In the Matter of: APPLICATION FOR CERTIFICATION FOR THE PALMDALE
HYBRID POWER PROJECT

**Testimony of Gregory Tholen
Autumn Wind Associates, Inc.**

**Palmdale Hybrid Power Project
Docket 08-AFC-9**

Re: Road Paving Offsets

Figure 1:
Fraction of PM_{2.5} (fine) and PM_{2.5-10} (coarse) in PM₁₀ emissions contained in entrained road dust from unpaved roads (left) and combustion exhaust from gas-fired stationary internal combustion engines (right)

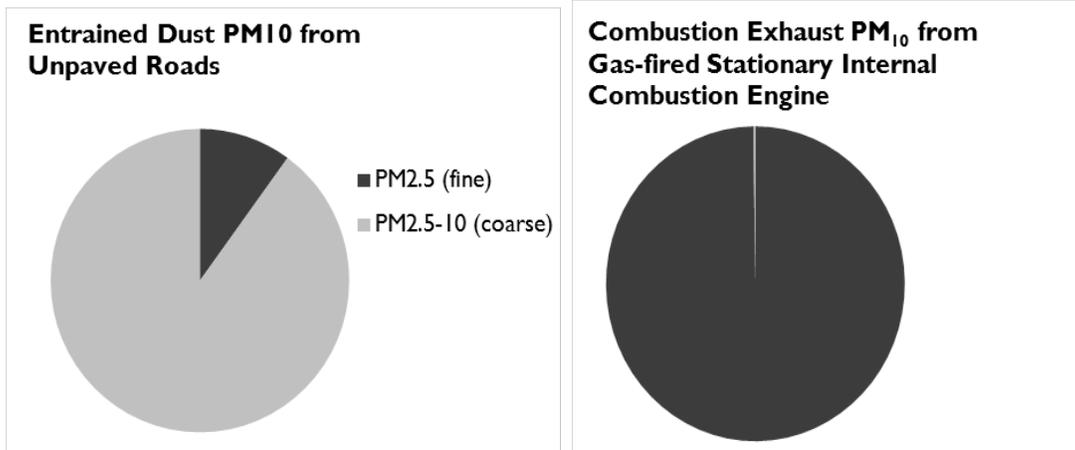
Numerous studies have shown that fugitive dust PM10 consists of about 90 percent coarse particulate matter, *i.e.* PM2.5-10, and only about 10 percent PM2.5 or fine particulate matter.² In contrast, combustion emissions from fossil fuel-fired sources are almost entirely composed of very small particulates. Figure 1 illustrates the fraction of PM2.5 contained in the PM10 emissions from entrained road dust from unpaved roads and combustion emissions from a gas-fired stationary internal combustion engine.

Figure 2:
Comparison of PM_{2.5} and PM_{2.5-10} size fractions in PM₁₀ combustion emissions increase from a natural gas-fired power plant and PM₁₀ entrained road dust emissions reduction from PERCs

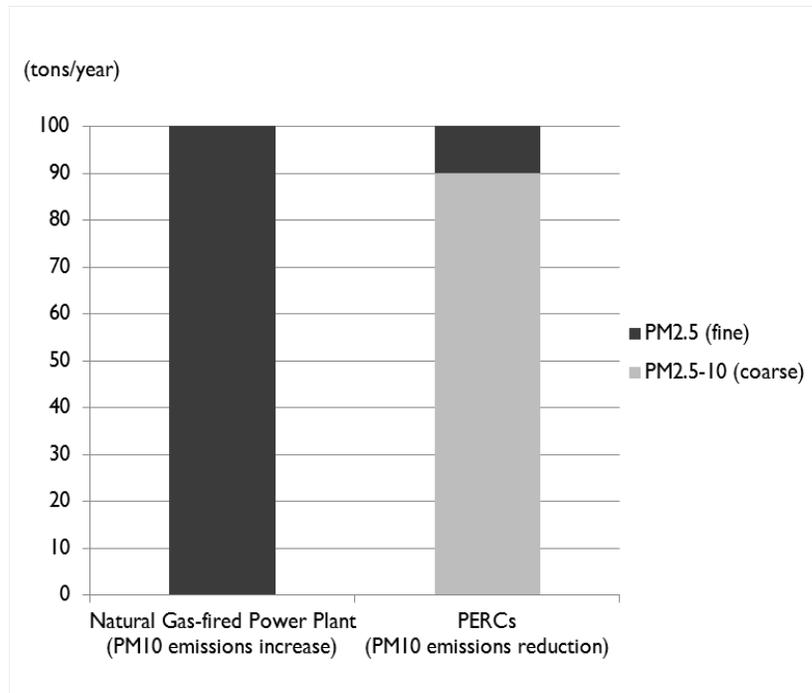
Figure 2 below illustrates how offsetting PM₁₀ emissions from a natural gas-fired power plant with entrained road dust-based PERCs would increase PM_{2.5} emissions.

Combustion emissions from the natural gas-fired power plant turbines are fine particulate matter, *i.e.* equal to or smaller than 2.5 micrometers. The PM₁₀ emissions reductions from paving an unpaved road consist of coarser particles with a diameter between 2.5 and 10 micrometers. Thus, when offsetting, for example, 100 tons/year of PM₁₀ combustion emissions with PERCs, 99.8 tons/year of PM_{2.5} emissions would be offset with 9.98 tons/year of entrained road dust PM_{2.5} and 89.82 tons/year of PM_{2.5-10}. Thus, the example offset scheme would result in a net increase of 89.8 ton/yr of PM_{2.5}, the fraction of particulate matter that poses the most significant health risk.
